CITY OF ST. FRANCIS
CITY COUNCIL AGENDA
June 4, 2018
ISD #15 CENTRAL SERVICE CENTER
4115 Ambassador Blvd NW
6:00 pm

Title of Item: **FINAL PLAT: Rivers Edge Planned Unit Development.** A resolution to approve the Final Plat and Final Plan for the Rivers Edge Planned Unit Development.

Summary: Staff, Engineering, and Legal have reviewed the final plat/plan application for the Rivers Edge Planned Unit Development (1st Addition) and find the documents to be complete, substantially conforming to the PUD Development Plan, and ready for approval. Specific issues of note include:

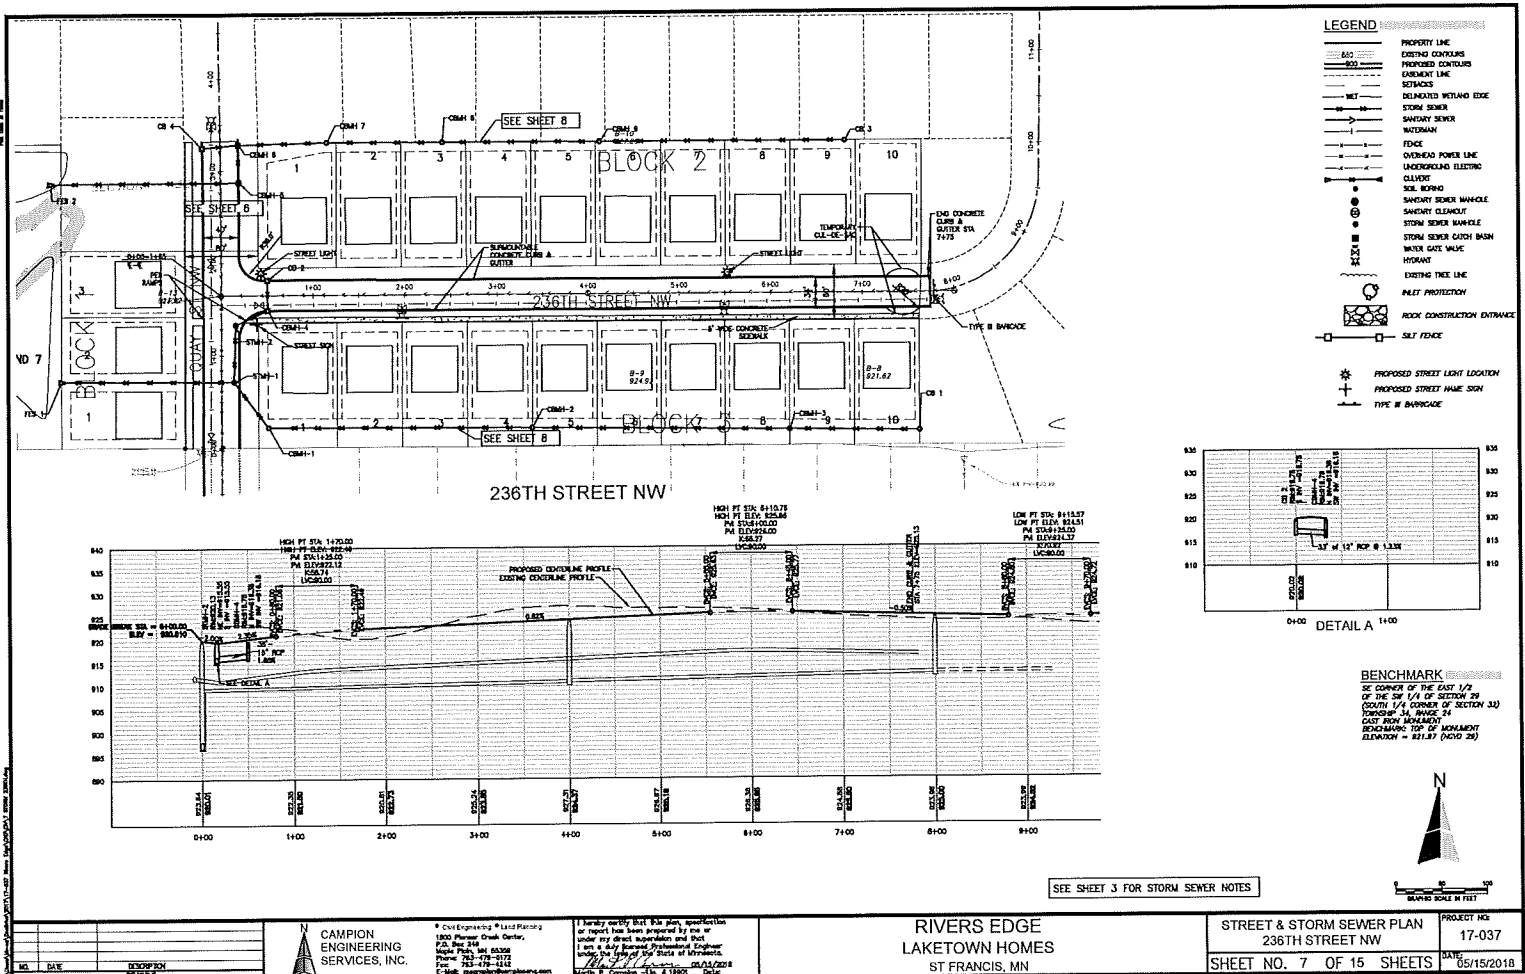
1. As per Storm Sewer Design comment #1, consider rerouting the storm sewer such that the pond 7 forebay can be eliminated. Connect pond 6 to pond 7 with a pipe or drainage swale.

5. Rip rap overflows or pipe conveyances are required for the forebays.
6. Access must be provided to all storm structures, flared end sections, rip rap overflows, pipes and ponds. Accesses must be at least 10 feet wide, contained within an easement, and have gradients that do not exceed 8%. Clearly label the access routes on the plans.

FIG2

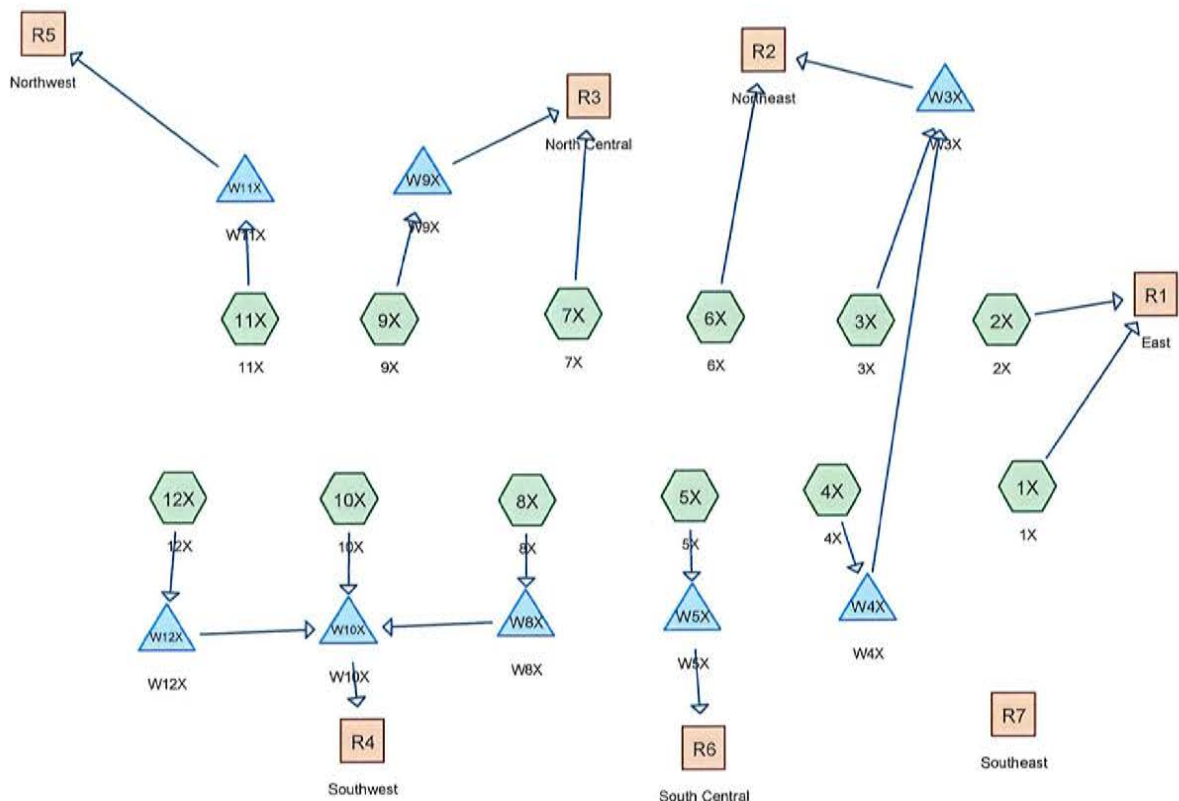
NOW THEREFORE, IT IS AGREED BETWEEN THE PARTIES AS FOLLOWS:

- a. Provide corrections to the final plat acceptable to City staff.
- b. Developer submits all plan sets which affect grading and erosion control and then updates and revises same for final approval of the City Engineer all prior to grading being authorized prior to the execution of the Development Agreement for this plat.
